GENERAL APPLICATION

Explanation of Request: Request for the construction of a new freestanding Chase Bank with a drive thru ATM and variances for drive-thru stacking (2) spaces; and (1) increase in max. parking count

On behalf of JPMorgan Chase, N.A., Core States Group ("CSG") is providing the following letter in response to comments issued on June 19, 2017 regarding a new Chase Bank located at 1700 Sheridan Street, Hollywood, FL 33020.

SHEET NO.
C7

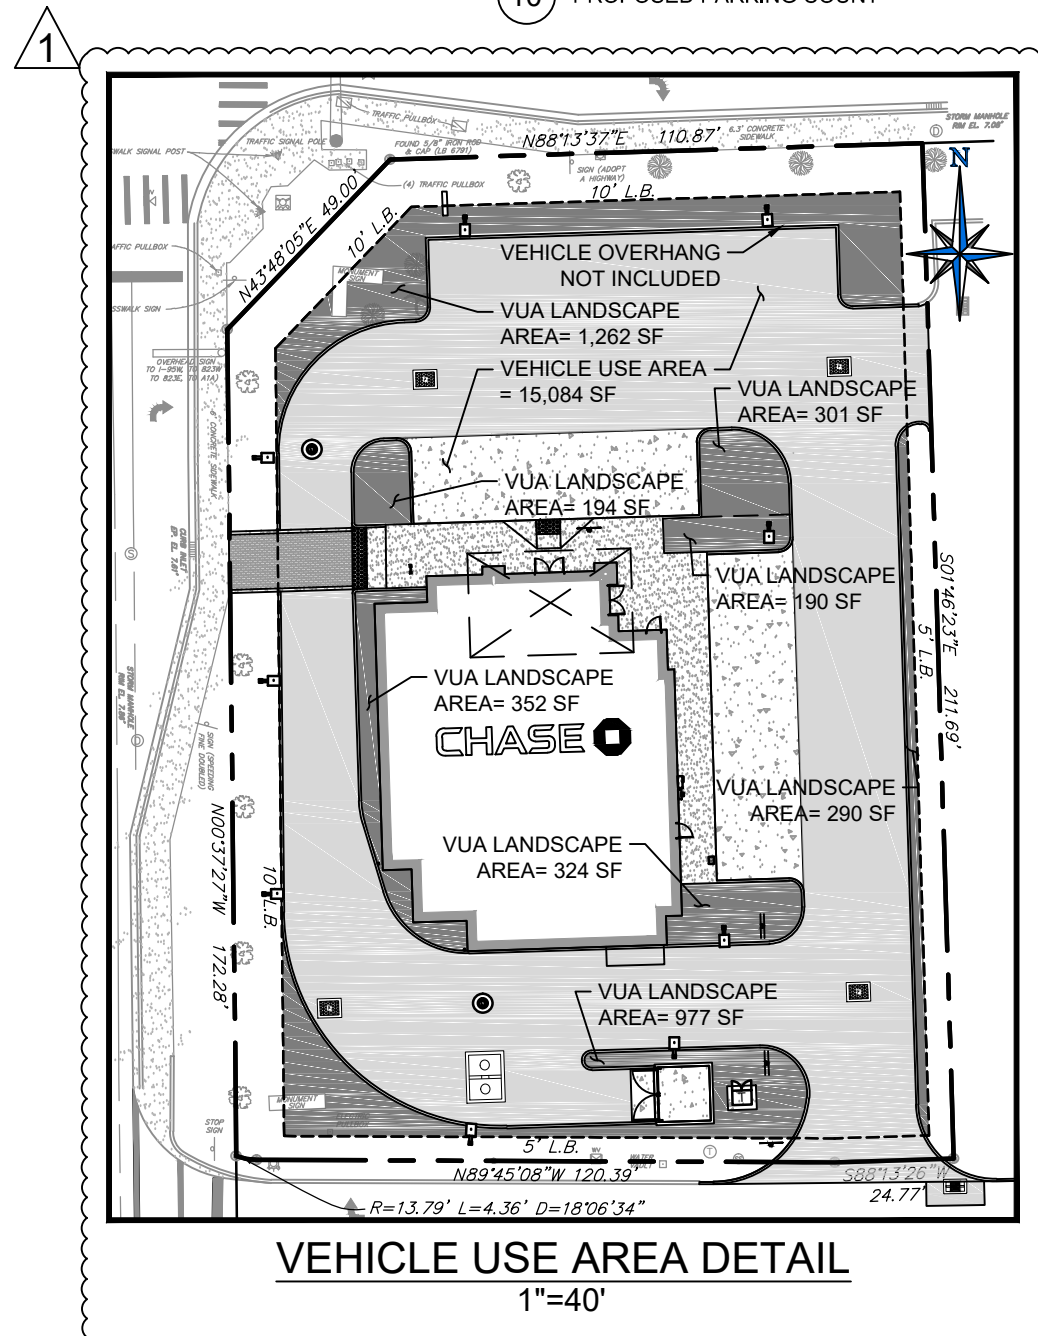
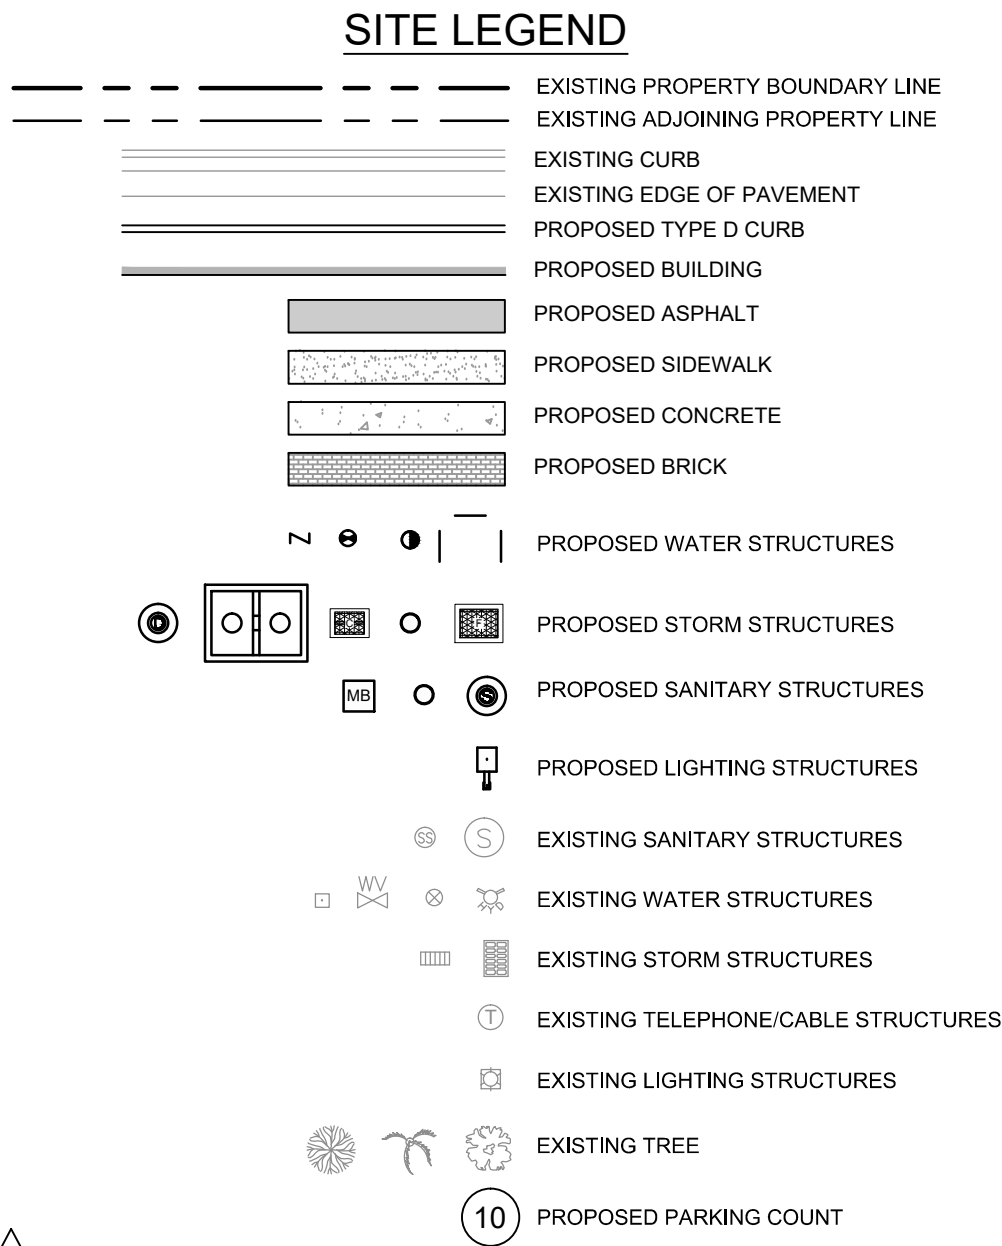
4. The square footage of the building is not consistent. Provide the actual square footage of the building and ensure it is the same on all documents including the general application, site plan, etc.

1. Revise Site data to include the correct Land Use and Zoning, and the correct required and proposed Heights, setbacks, etc. Existing information shall be removed as this is a vacant parcel. Please reference Ordinance O-2016-22 as this area was rezoned.

2. The proposed parking exceeds the maximum allowed in this zoning district. Revise Accordingly.

4. Parking stalls shall be 8.5x18 feet long or 17 feet with a one foot grass overhang. Dimension stalls and revise as necessary. One foot overhang does not count towards landscape calculations.

5. All terminal islands shall be a minimum of 190 square feet and have a length equal to that of the adjacent parking stall. Show dimensions for compliance.

1. Include note on Site Plan stating the maximum foot-candle level at all property lines (maximum 0.5 if adjacent to residential).

1. Indicate the one outbound stacking space for the drive-thru ATM on plans.

Response: Please refer to the revised Sheet C7, Site Plan, and the general application for the updated building area.

Response: Please refer to the revised Sheet C7, Site Plan, for revised site data table for the above corrected information.

Response: Please refer to the revised Sheet C7, Site Plan, for the revised requested variance table. Please note that during the Preliminary TAC hearing, staff indicated that the proposed project may be alleviated from the maximum requirement based on it being in a master planned development. Please note the request for landscaping variance has been removed and one parking stall has been removed from the plans. The current plans show 24 proposed spaces, with a maximum of 23 per code. Based on the approved plans for the overall development, the site as a whole, was granted additional parking over which was required.

Response: Please refer to the revised Sheet C7, Site Plan, for the revised parking stall dimensions and VUA Detail. No overhang was included in the VUA landscaping parking calculation. Please note the request for landscaping variance has been removed and parking space dimensions revised.

Response: Please refer to the revised Sheet C7, Site Plan, for the updated terminal landscape islands to be a minimum of 190 SF.

Response: Please refer to the revised Sheet C7, Site Plan, for site note 7 regarding site lighting.

Response: Please refer to the revised Sheet C7, Site Plan, for the outbound stacking location.

SHEET TITLE
UTILITY PLAN

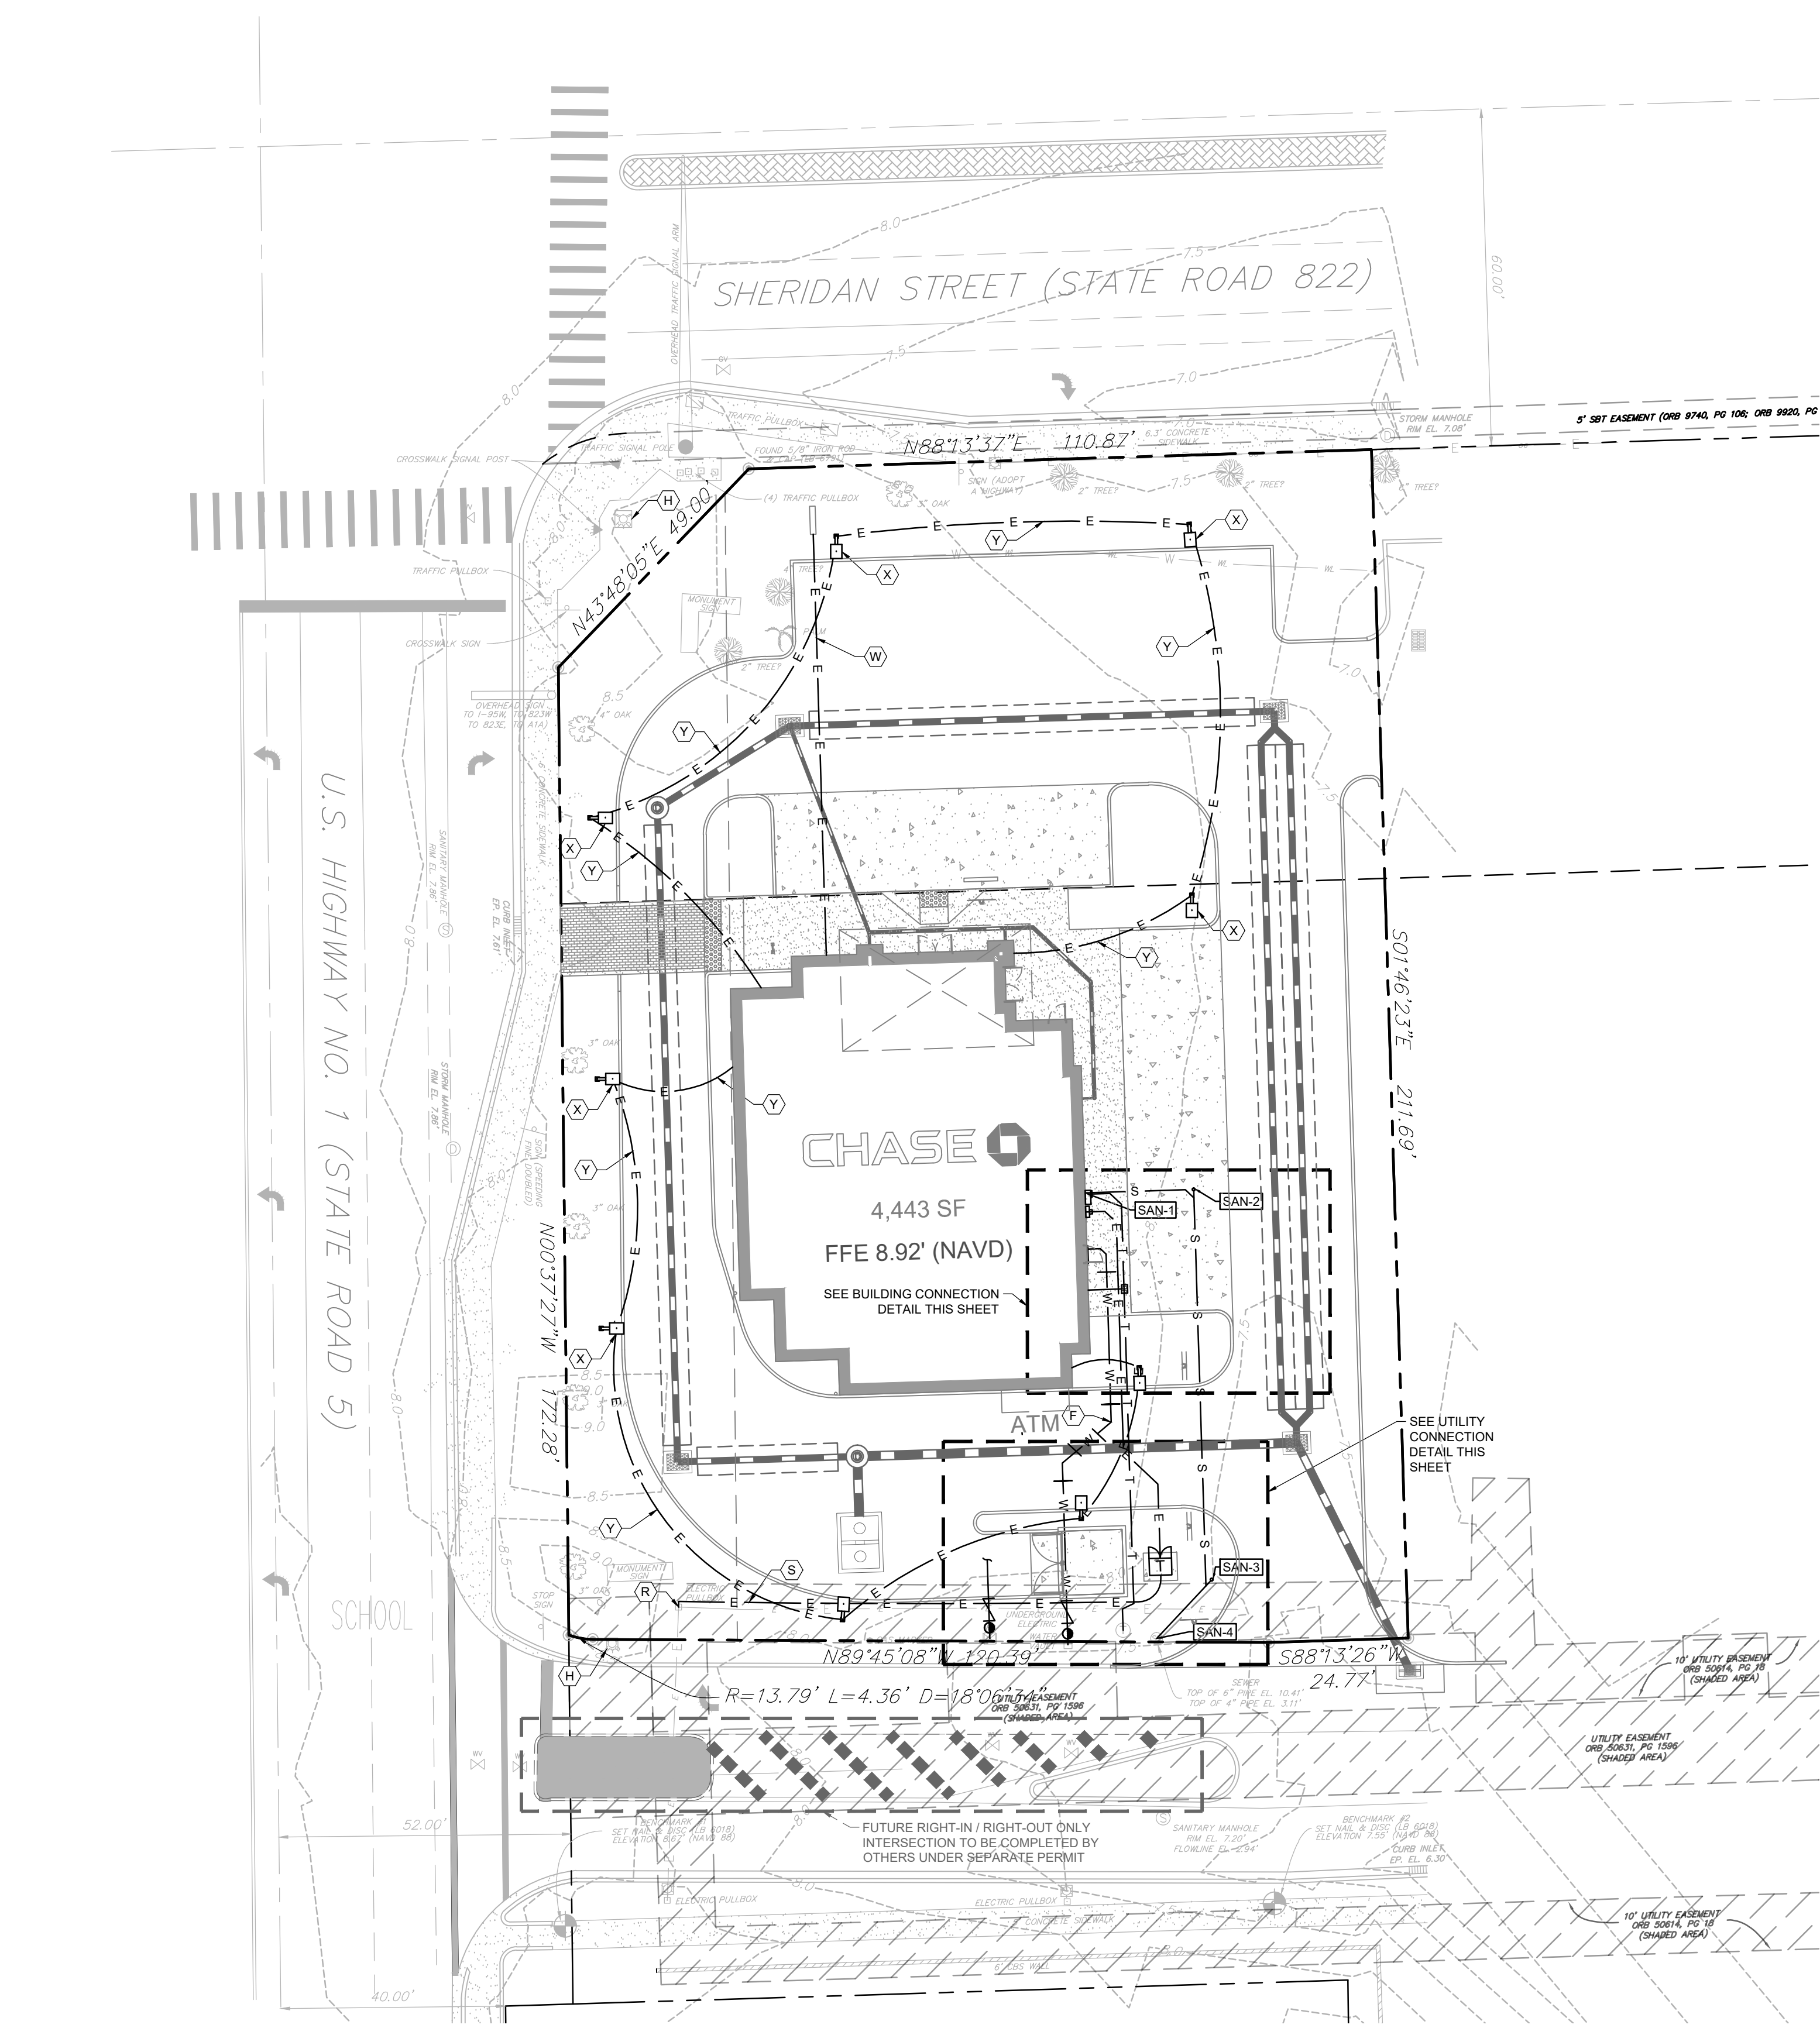
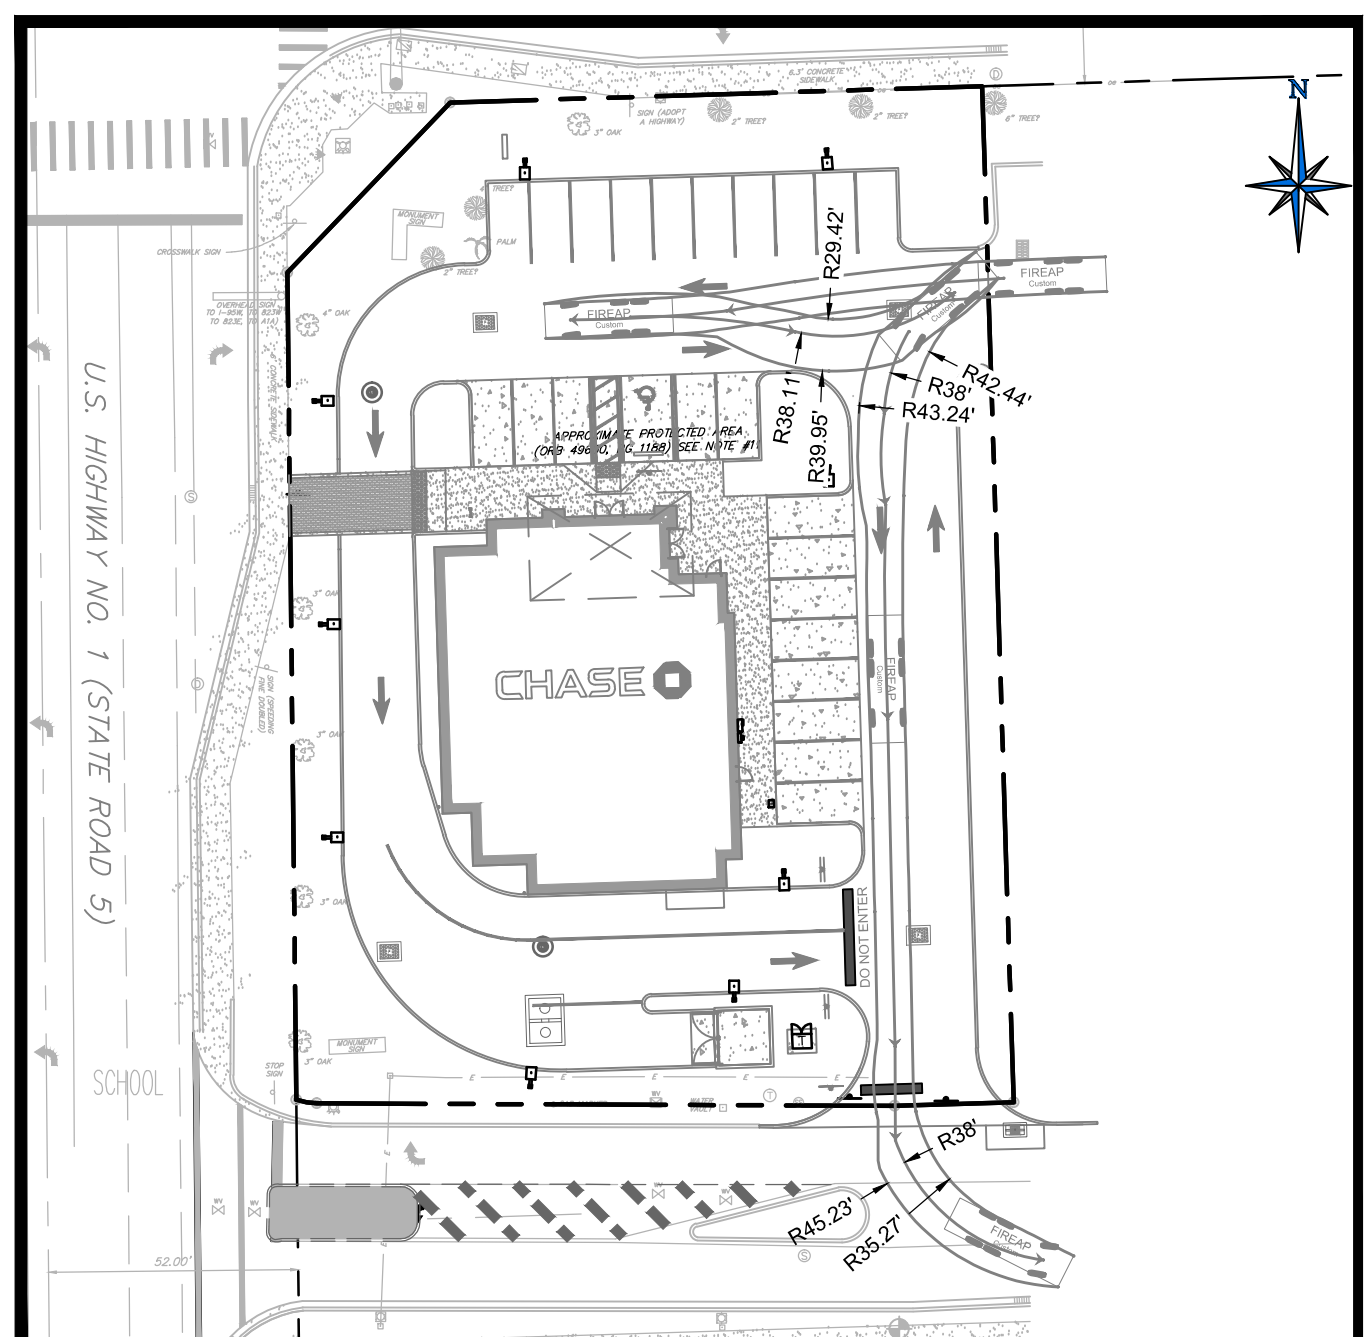
1. On pg. C9, fire truck turn is shown. However, on the west side of the building, a minimum width of unobstructed access of 20' width is required per NFPA 1, chapter 18.2.3.4.1.1. Please show on one of the pages. Pg. C7 only shows a 15' width for the access.

2. Our required turning radius is: 28'.5" interior radius, 38' centerline of the turning radius, and 45' exterior. Please show on the plan.

3. In order to determine the minimum fire flow requirements found in NFPA 1, 18.4.5.2, a fire flow test must be scheduled. Please call underground utilities to schedule at 954-921-3046. After the results are completed, show the calculations on the next submittal showing how the minimum

4. Additionally, no legend appears on pg. C9 for fire hydrants. If there are existing fire hydrants, Please show them on the plan.

Response: Please refer to the revised Sheet C9, Utility Plan, for the revised fire truck turn analysis. Please note that the truck turn analysis was revised to not show the fire truck traverse the 15' wide lane as it is not required for the fire access road. The fire access road as shown conforms to NFPA 1 standards and is within 150' of any portion of any exterior wall (18.2.3.2.2), and within 50' of any exterior doorway (per 18.2.3.2.1).

Response: Please refer to the revised Sheet C9, Utility Plan, for the revised fire truck turn analysis which does not require the vehicle to turn at the minimum allowed radii.

Response: Please refer to the attached fire flow test and refer to keynote “H” as initially submitted. Please note there are two (2) existing hydrants adjacent to the site, one located at the northwest corner and one located at the southwest corner.

Response: Please refer to the revised Sheet C9, Utility Plan, for the existing water structures legend and keynote “H” as initially submitted. Please note there are two (2) existing hydrants adjacent to the site, one located at the northwest corner and one located at the southwest corner.
